NATIONAL GRID COMPANY plc**Background Information to Grid Code Consultation Document D/03****“Grid Code Changes to Incorporate New Generation Technologies and DC Inter-connectors (Generic Provisions)”****Introduction**

National Grid Company plc
6 June 2003

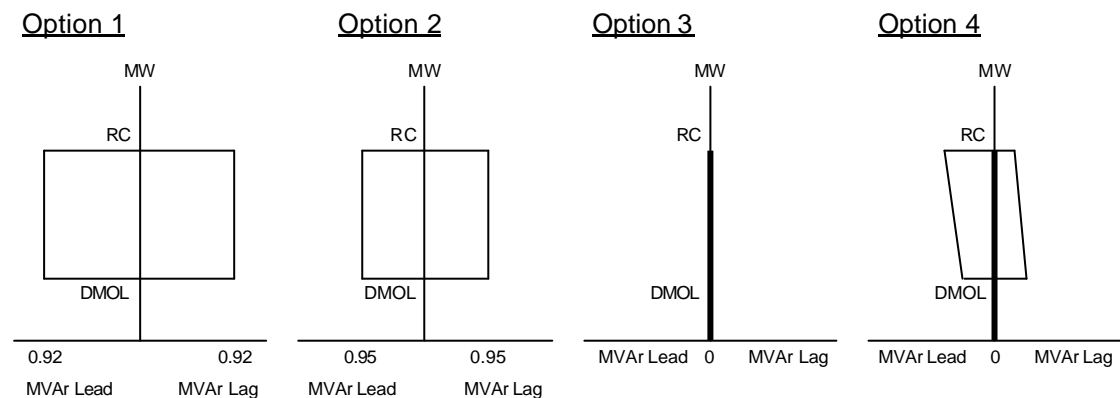
- Option 1 – Capability of +/- 0.92 power factor at the HV connection point. This is nominally equivalent to the current requirement for synchronous machines.
- Option 2 – Capability of +/- 0.95 power factor at the HV connection point. This is similar to Option 1 but with the range reduced in line with Grid Code Reactive Power Working Group recommendations.
- Option 3 – Capability of unity power factor. Based on the recommendations of the Grid Code HVDC Working Group and similar to the bare minimum operational requirements of the Grid Code Reactive Power Working Group.
- Option 4 – Capability at the connection point resulting from +/- 0.95 power factor at the individual unit LV terminals. The capability always includes unity power factor at the connection point.

The four options are illustrated below.

Having considered these four options, National Grid has proposed a development of the Grid Code based on Options 2 and 3. The reactive capability proposals (see Grid Code CC6.3.2) have been drafted to reflect both the needs of the transmission system in terms of security and quality of supply and the need to allow the continued development of the new technologies to provide improved capability. To allow time for this and to provide an appropriate signal of the transmission system requirements in the longer term, a staged introduction of the requirements is proposed. This can be summarised as:

Wind farms, non-synchronous generating units and DC converters with completion dates prior to 1 January 2006 would be required, as a minimum, to be capable of operating to an instruction for zero MVAR transfer at the connection point i.e. operation at unity power factor. To ease this requirement further, a tolerance around the dispatch instruction would be acceptable and this would be specified at the connection offer stage in the Bilateral Agreement.

Wind farms, non-synchronous generating units and voltage-source DC converters with completion dates on or after 1 January 2006 would be required to have a symmetrical reactive power capability between a leading and lagging power factor of 0.95 at the connection point (Option 2). This is in line with the Reactive Power Working Group's recommendations.

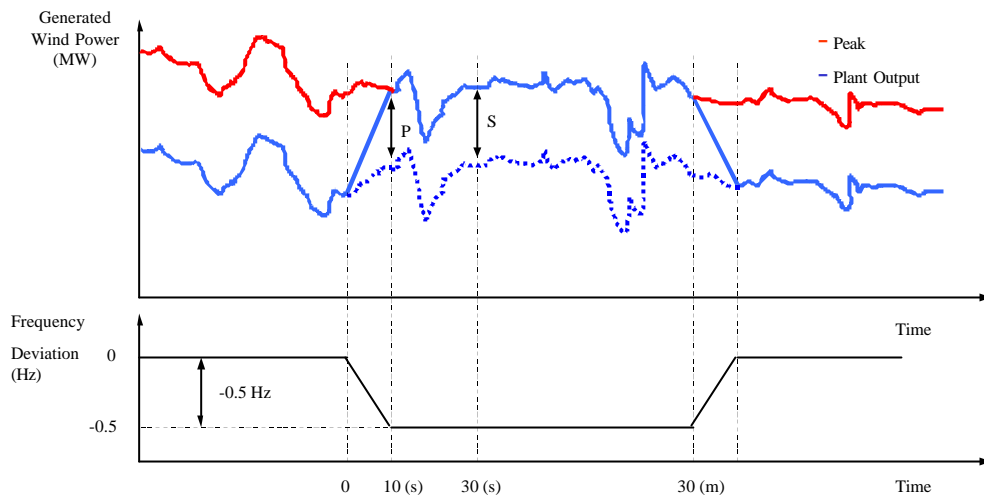
National Grid believes that it is reasonable to require the new generation technologies with completion dates on or after 1st January 2006 to provide a full frequency response capability. This view takes into account the following:

New generation technologies commissioning before the 1st January 2006 will be required to be capable of limited frequency sensitive operation. Essentially this requires generators to be capable of reducing active power by at least 2 percent of output per 0.1Hz deviation of system frequency above 50.4 Hz. This can be delivered from wind farms either by controlling the power output from individual wind turbines or by reducing the number of wind turbines generating within the wind farm.

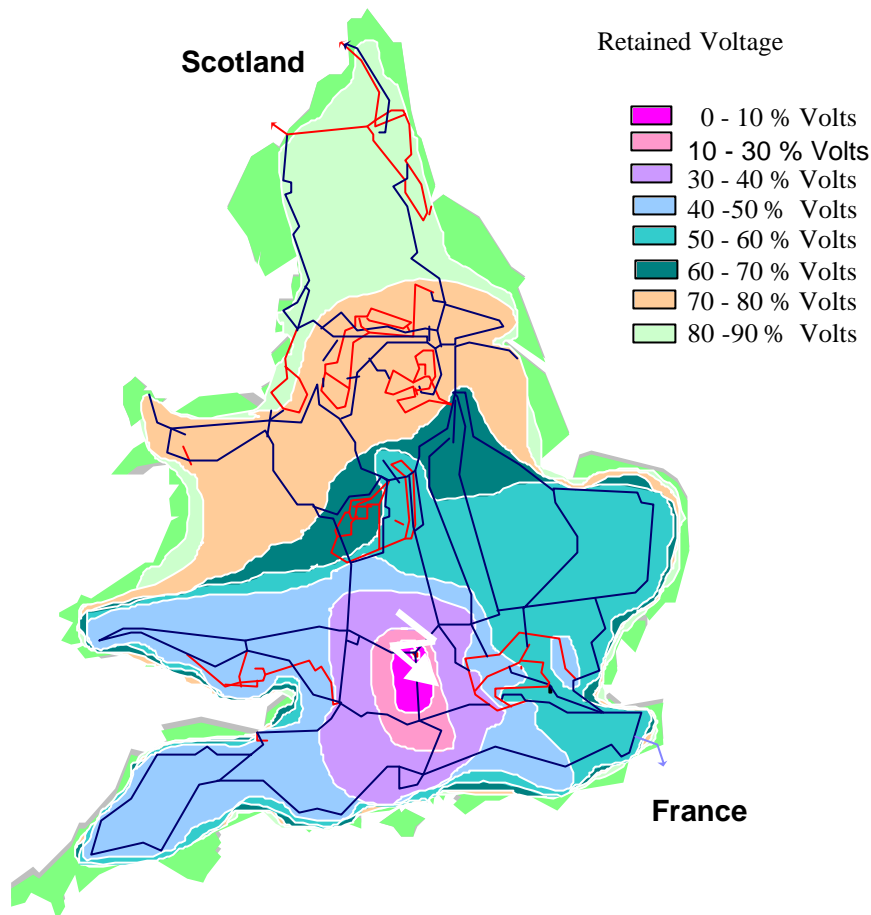
For clarity, the requirement to withstand faults on the transmission system has been added to the Grid Code. Without this ability there will either be a significant increase in the risk of customer disconnection spread across the whole country following a single fault, or there will be severe restrictions on the future concentrations of wind farm development in local areas.

This is illustrated by the figure below where the voltage across the system during a 3 phase fault applied at Cowley 400 kV substation is shown. It can be seen that all substations in England and Wales are temporarily exposed to levels of less than 90 % of nominal voltage. The area where transmission system voltages are depressed below 10% covers a large part of Oxfordshire despite the presence of a large synchronous generator connected to the adjacent substation.

Some wind turbine technologies are reported to be susceptible to tripping even if the voltage transiently falls to levels as high as 70 %. The outcome of this would be significant volumes of generation would be lost. In this example all wind farms in the South of England and Wales would disconnect.

In order to relax and ease this requirement as far as practicable, fault ride-through capability is only required for faults on the 400/275 kV transmission system because of the wide propagation of the voltage disturbance. For faults at 132 kV and lower voltages the impedance of the supergrid transformers limits the severe transient voltage depression across the transmission network. However the voltage on the distribution system will be depressed. Current expectations are that it is unlikely that very large amounts of wind farm generation (exceeding 1320MW) can practically be connected within such a 132kV distribution group. From the transmission operators point of view, fault ride through capability for distribution faults should not be an issue because the simultaneous loss of large amounts of centrally connected generation would be very unlikely to be beyond the credible loss limit of 1320 MW.
